Midpeninsula Regional  
Open Space District

Approval of the Bid Plan Set for the Mount Umunhum Road Improvement Project and Authorization to Release the Request for Bids

# MT. UMUNHUM ROAD DESIGN PROJECT

## April 7, 2016 SET

# **5** PRE-CAST CONCRETE BARRIER END SECTION

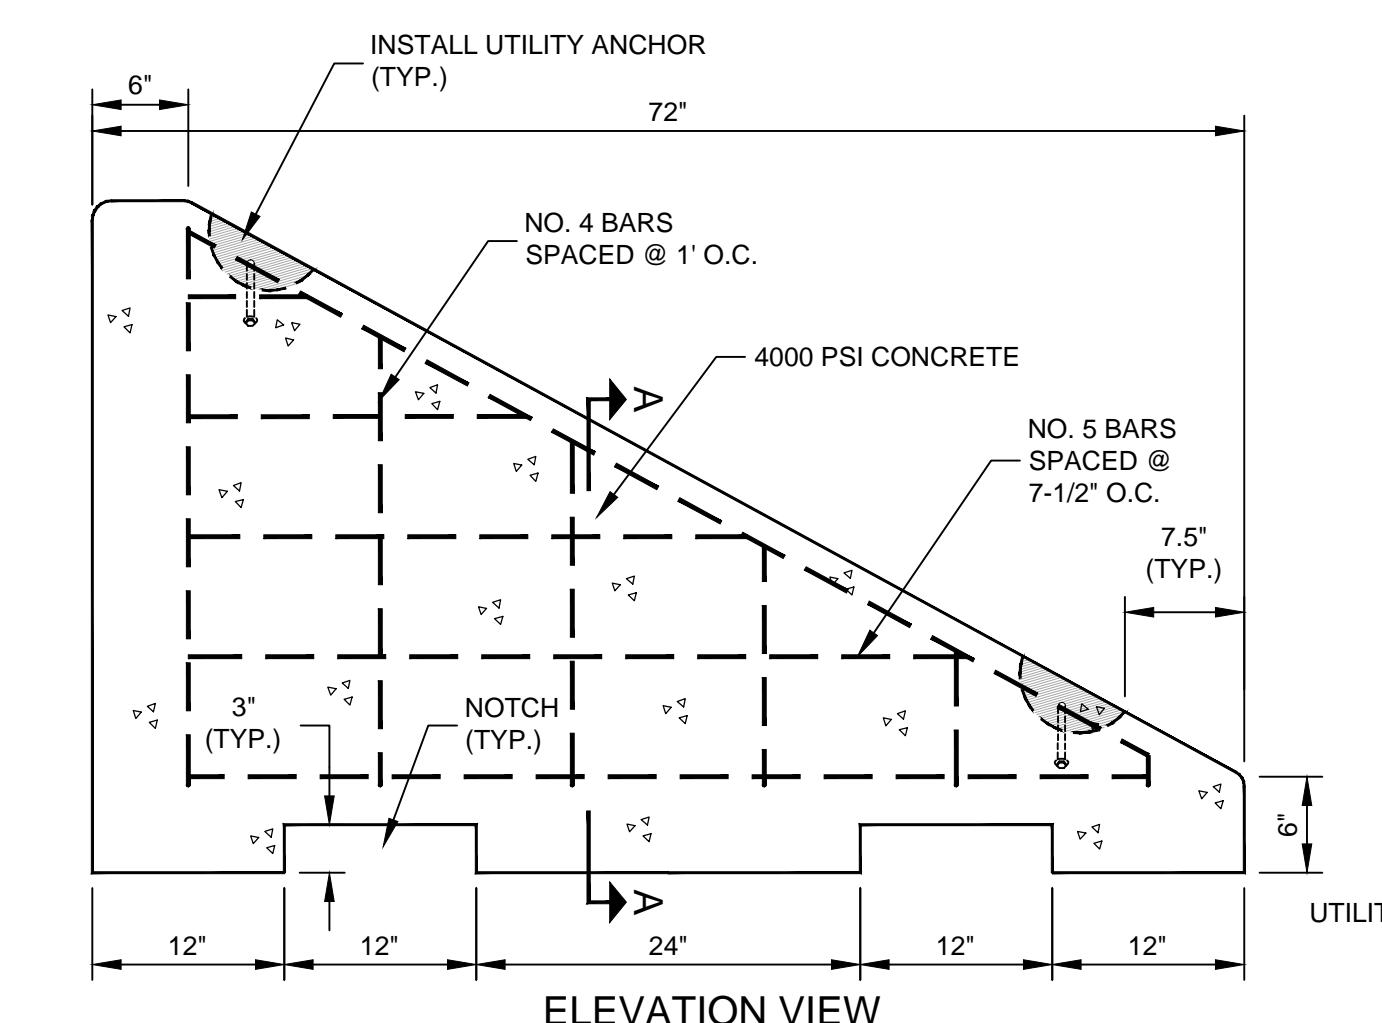
Comment #7: Pre-Cast Concrete Barrier detail – Bevel dimension.

## **2 CONDUIT TRENCH CROSS-SECTION**

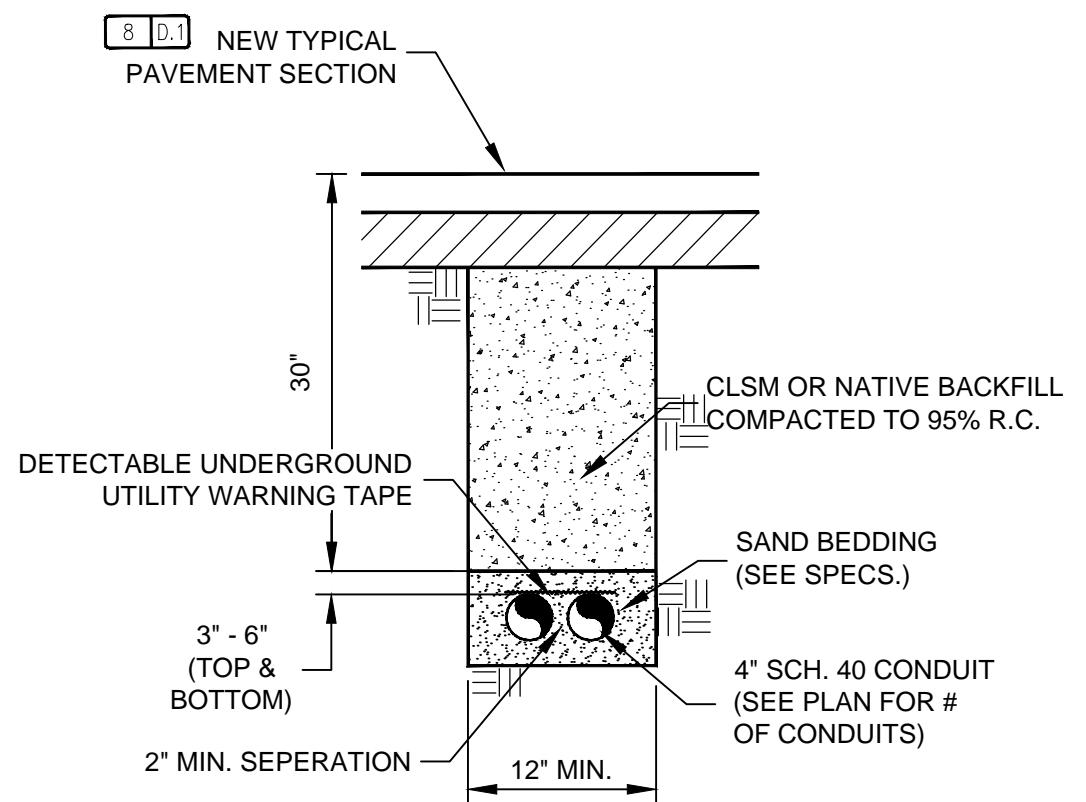
Comment #6: Conduit Trench Cross-Section detail – Add a Tie In New Conduits note.

# 1 CULVERT TRENCH CROSS-SECTION

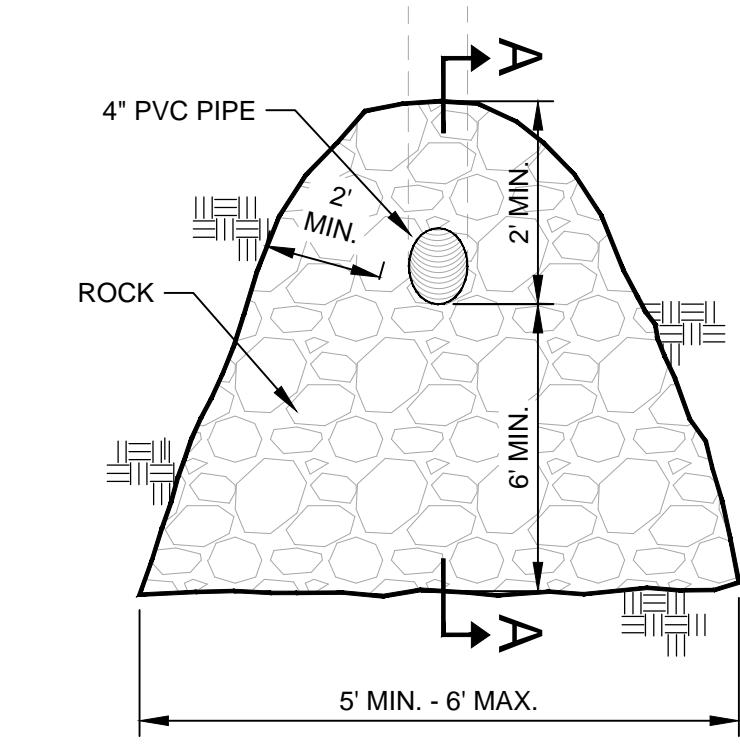
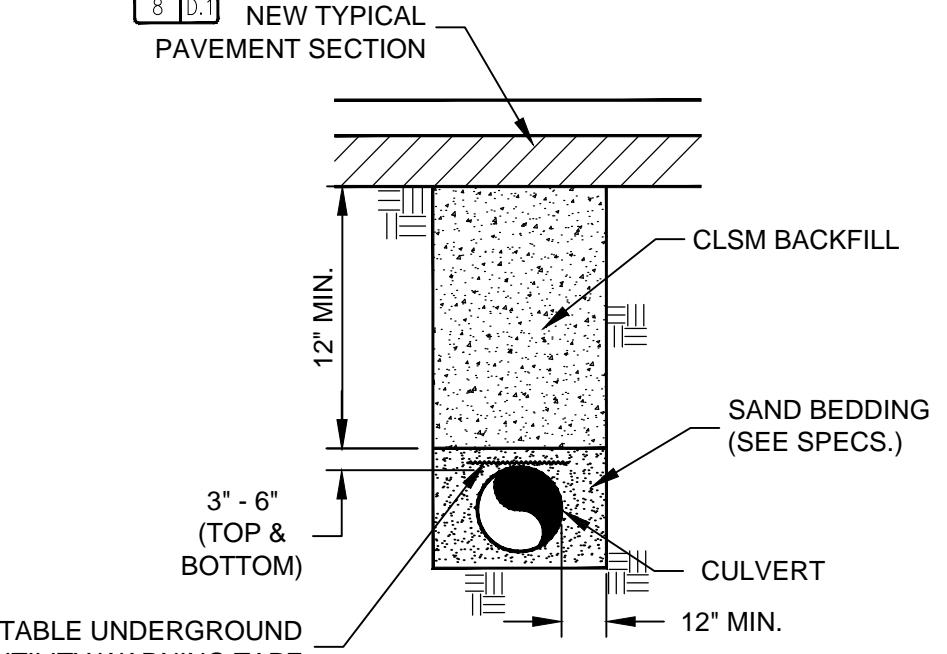
Comment #4: Culvert Trench Cross-Section detail – Add Compaction % to backfill.
